Technical Information

Ref No. : ZSL00012
Date : November 29, 2005

Restoring TV function of IC-7000

D2156
D2155
D2154
D2152
D2153
D2151
D2174
D2176
D2175
D2177

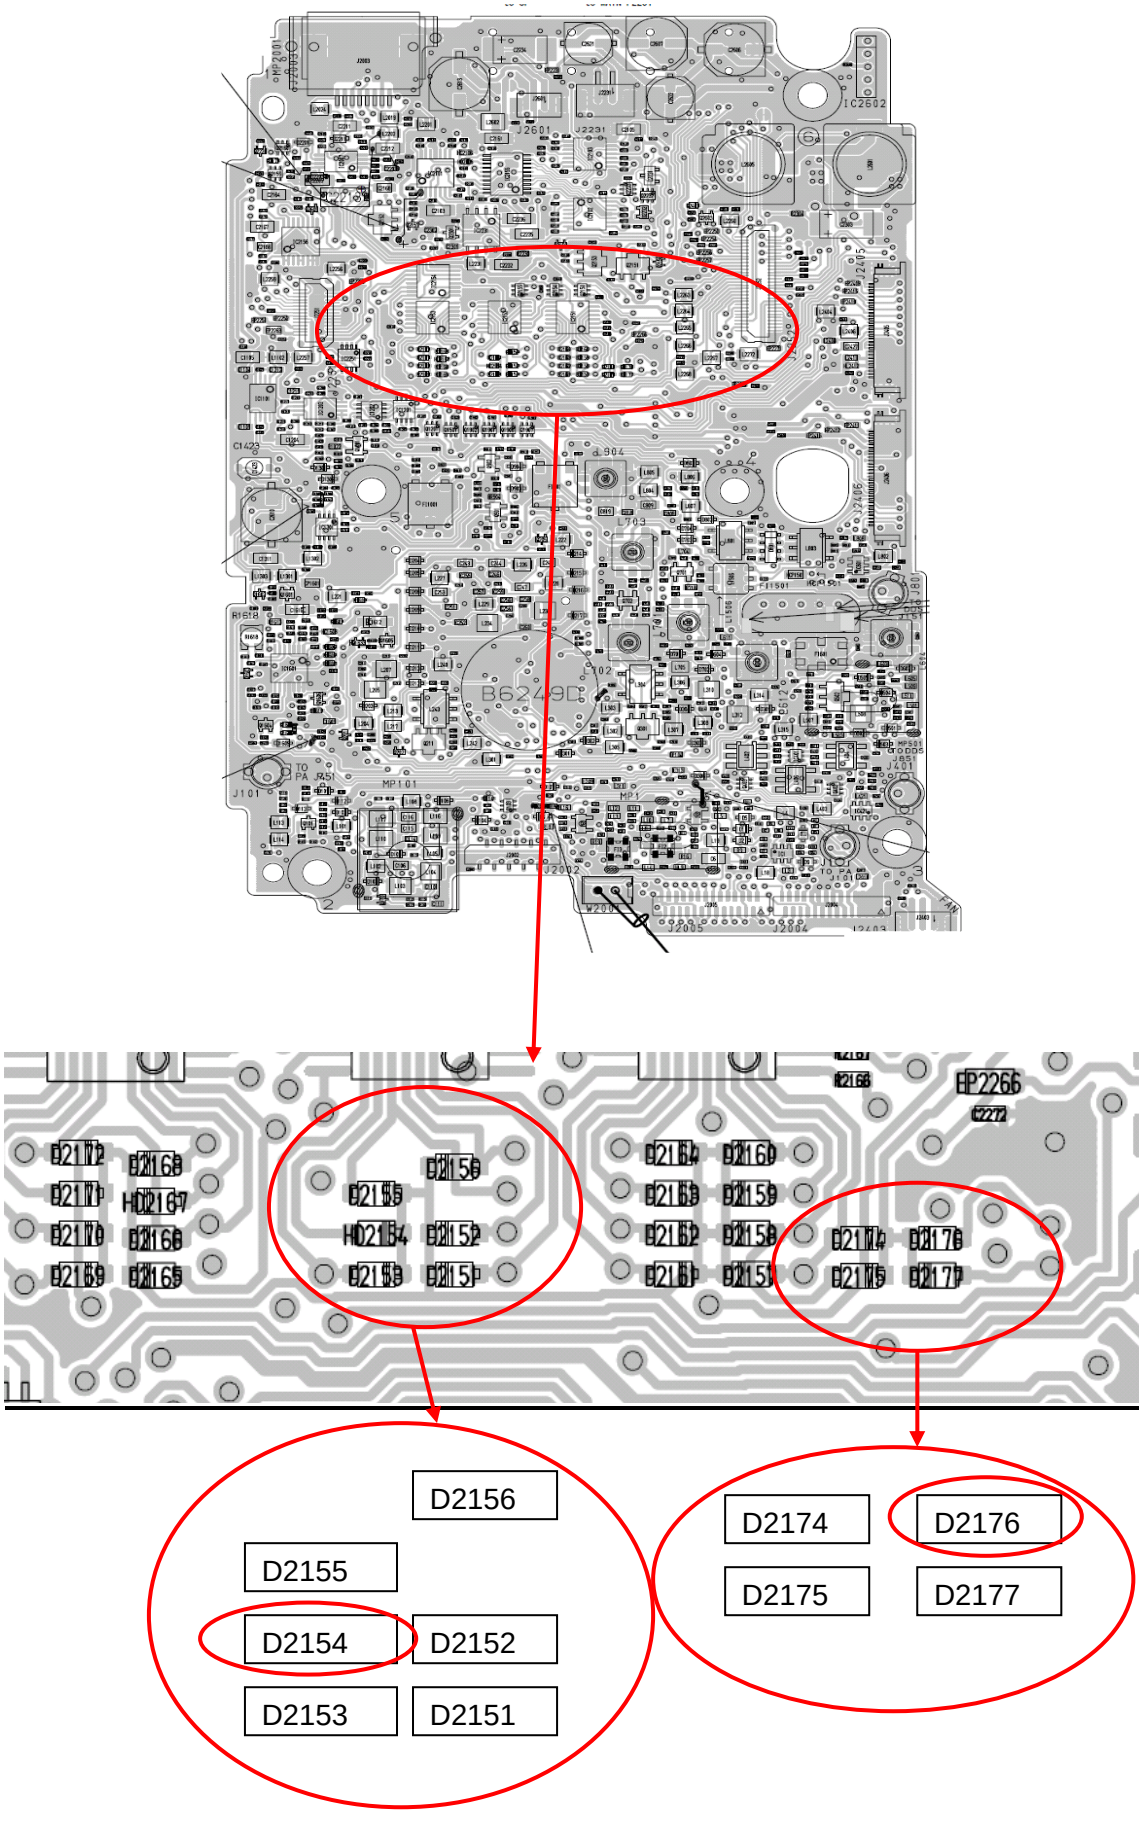
Following information is regarding the modification of restoring TV function of the IC-7000. TV function is concealed to keep security for operation in a car.
But it is possible to restore the TV function if the IC-7000 will be used at a fixed location.

Restoring TV function

NO TV
D2154	YES

WITH TV
D2154	NO

Showing warning sign

IC-7000 can show warning sign when power is put on.
*This modification is required for the areas where warning is compulsory for TV operation in a car.

NO TV
D2176	NO

WITH TV
D2176	YES
